COUNCIL MEETING

7.7 North East Link South Alliance Urban Design and Landscape Plan submission

North East Link Eastern Freeway Upgrades - Burke Road to Tram Road - Urban Design and Landscape Plan

Figure ~~20202020~~ Zone 3 of the Koonung Creek Reserve Concept Design

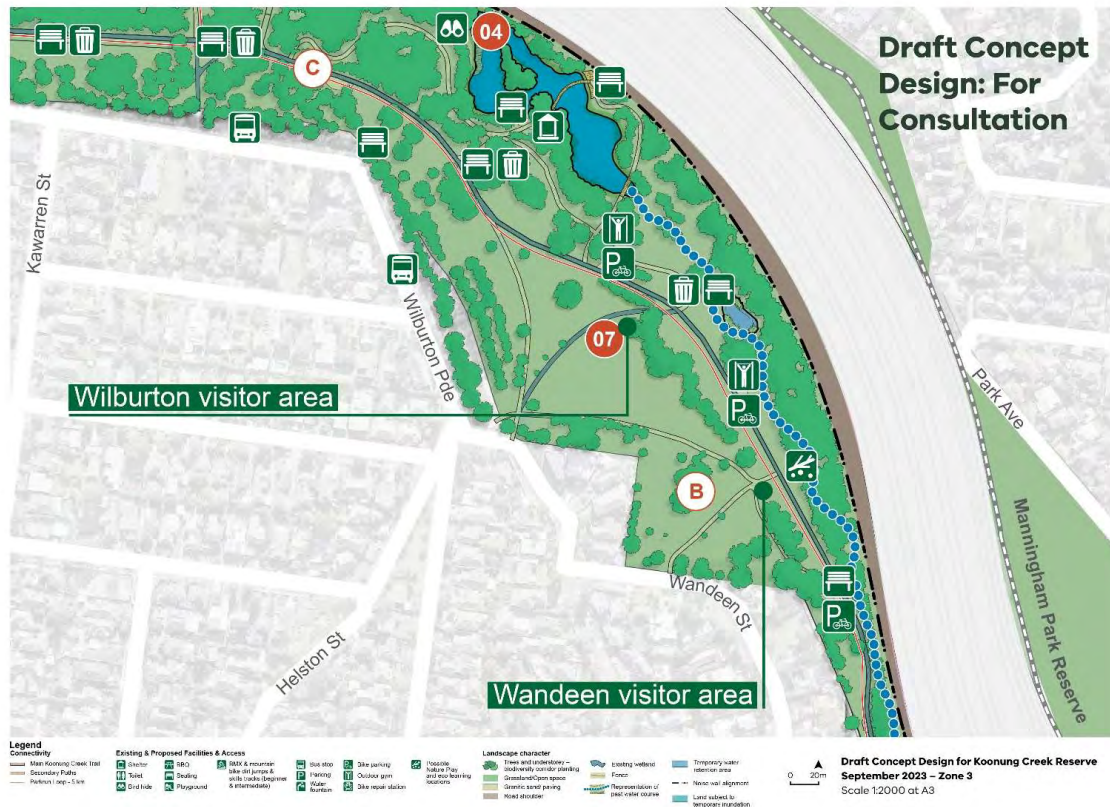
The below represents the feedback received on Zone 3:

Figure ~~2121212121~~ Zone 4 of the Koonung Creek Reserve Draft Concept Design

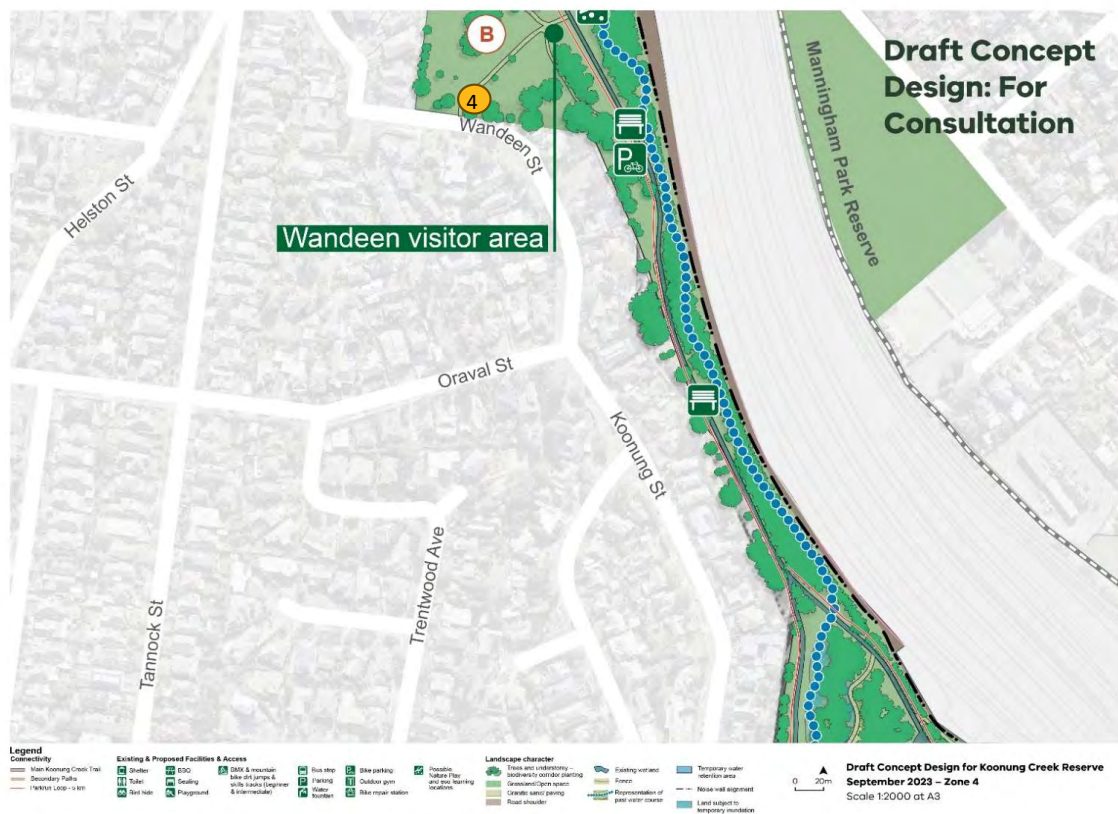
There were annotated comments on Zone 4 and Zone 5. Where comments are specific to a location, they are numbered on the map, with a 'key' to detail their comments.

Numbered item (orange circle):

5.2 Musca Street Reserve

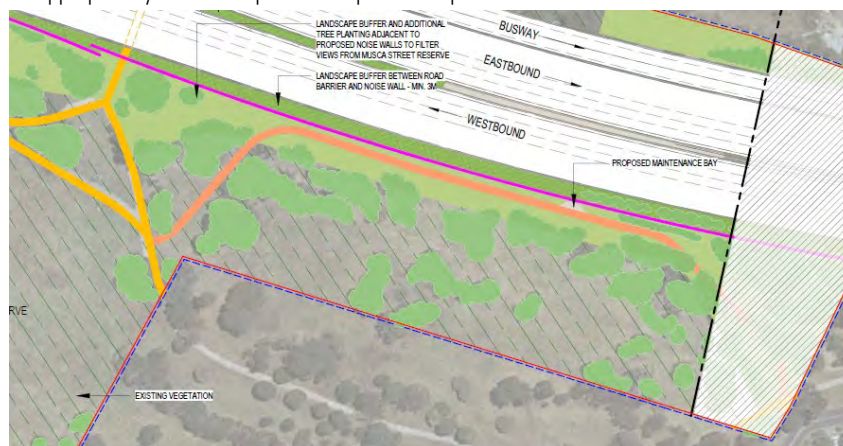
62. The encroachment of the freeway south into the open space illustrated on Landscape Drawing NO. 9536 is minimal and largely within the footprint of the existing freeway corridor. To the northwest portion of the open space, there appears to have been a gain of 2,752m² based on the difference between the existing fencing vs proposed noise wall alignment.

63. Despite this, considerable loss of vegetation is recorded along the northern edge of the reserve as per the Tree Removal & Reinstatement Plan snip below. It is understood that vegetation loss is linked to the construction of new noise walls. Given that the scale of Musca Street Reserve offers a generous buffer to residential land, it is recommended that the existing noise walls are retained if vegetation retention can be maximised.

Doncaster Road Underpass

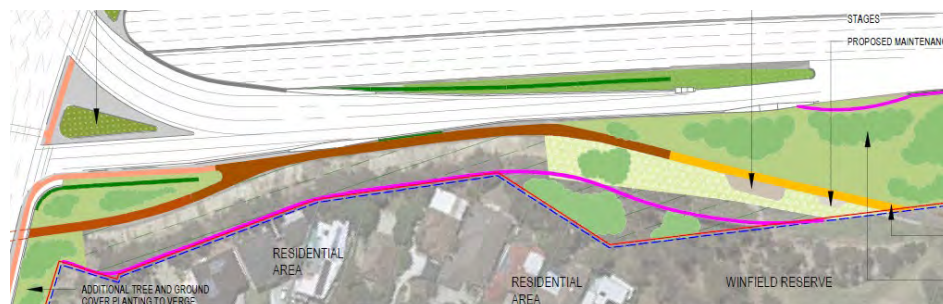
98. At the eastern edge of the reserve is the Doncaster Road underpass that is earmarked for upgrade. Proposed works are noted to include increased dimensions (to 7m wide), CPTED enhancements, functional and feature lighting and the application of brighter and textured materials to minimise darkness and the sense of enclosure.

Figure 20 Zone 3 of the Koonung Creek Reserve Concept Design

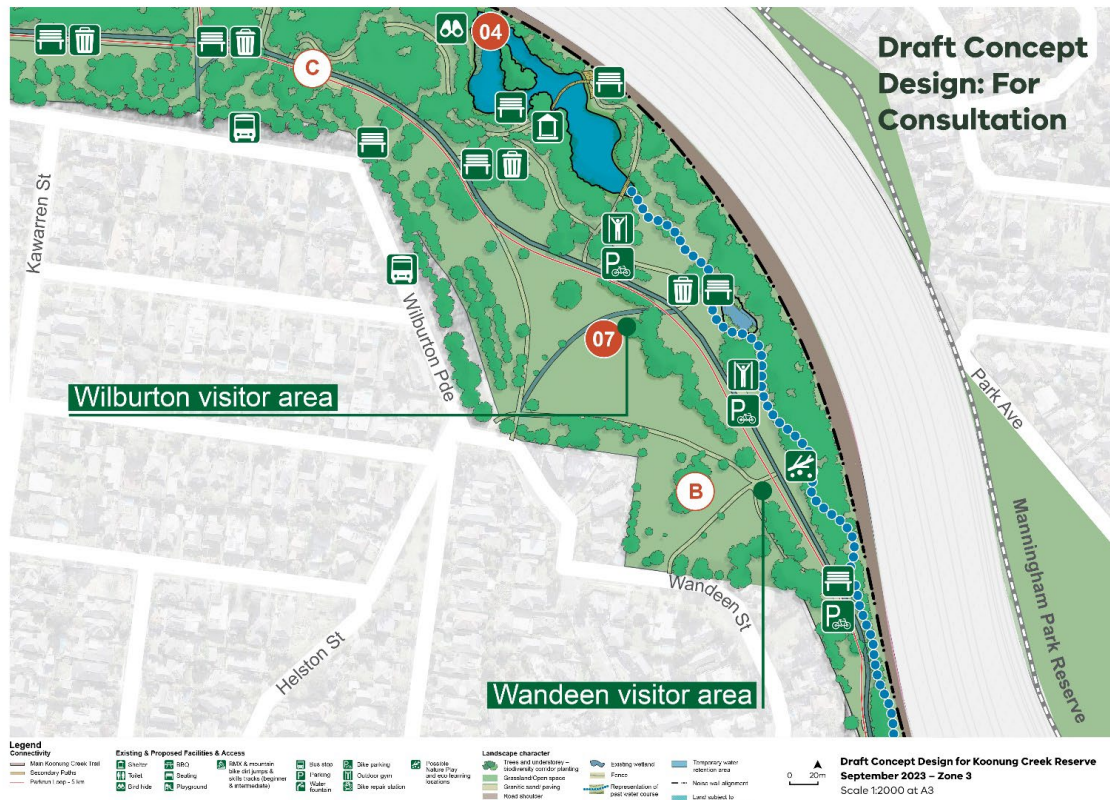
The below represents the feedback received on Zone 3:

Figure 21 Zone 4 of the Koonung Creek Reserve Draft Concept Design

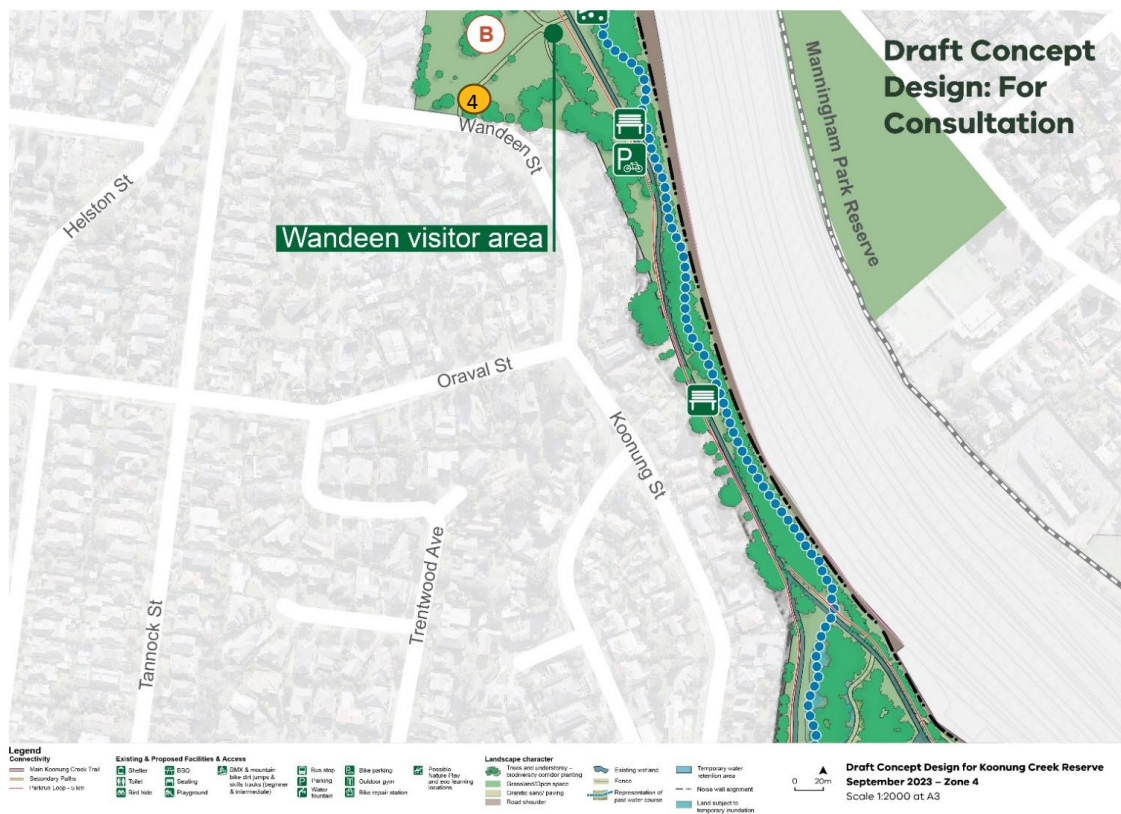
There were annotated comments on Zone 4 and Zone 5. Where comments are specific to a location, they are numbered on the map, with a 'key' to detail their comments.

Numbered item (orange circle):
